# EXPLODED VIEW

### PRO INVERTER

#### MODEL:

# OVEN CAVITY PARTS

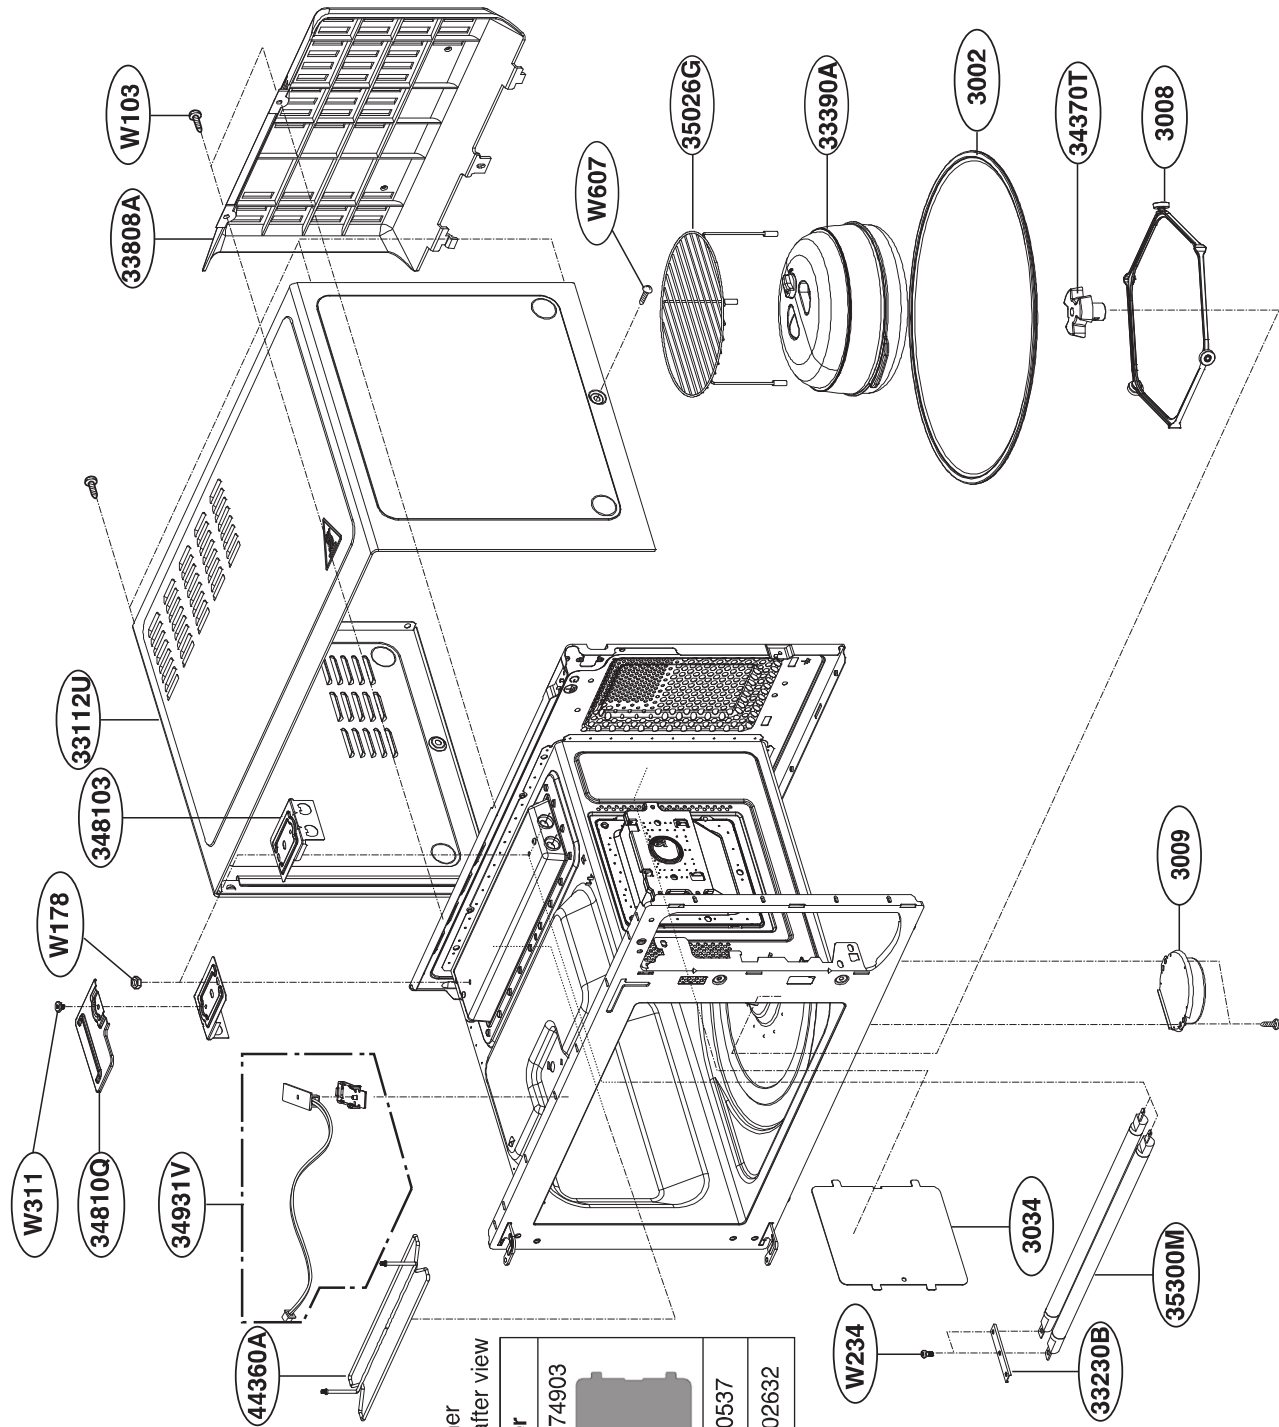
| Part Name        | Before      | After       |
| Cover, Insulator | MCK69074902 | MCK69074903 |
| Cavity Assy      | ABU740537   | ABU740537   |
| Screw            | -           | 1TTG0402632 |

# INTERIOR PARTS

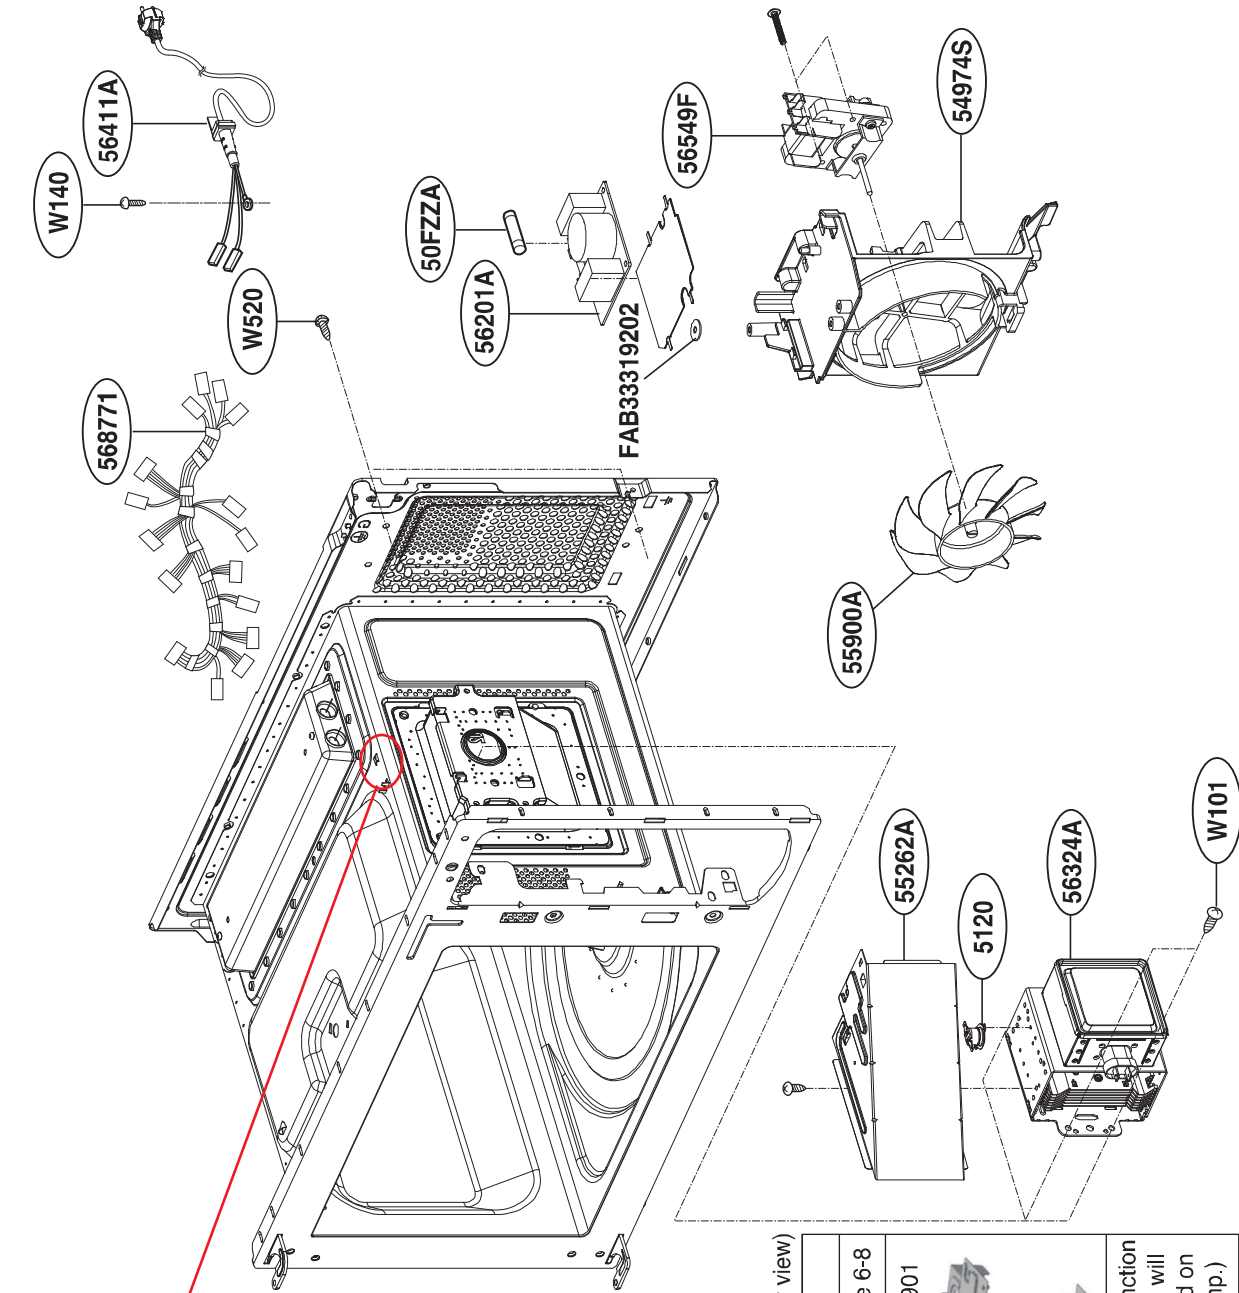
| Part Name     | Before                                                               | After                                                                |
| PCB           | Refer to page 6-8                                                    | Refer to page 6-8                                                    |
| Duct          | MCZ64052102<br>                                                      | MCZ64391901<br>                                                      |
| Cooling Logic | After cook finish, Cooling fan will work for one minute obligatorily | Delete the function (Cooling fan will work depend on inverter temp.) |
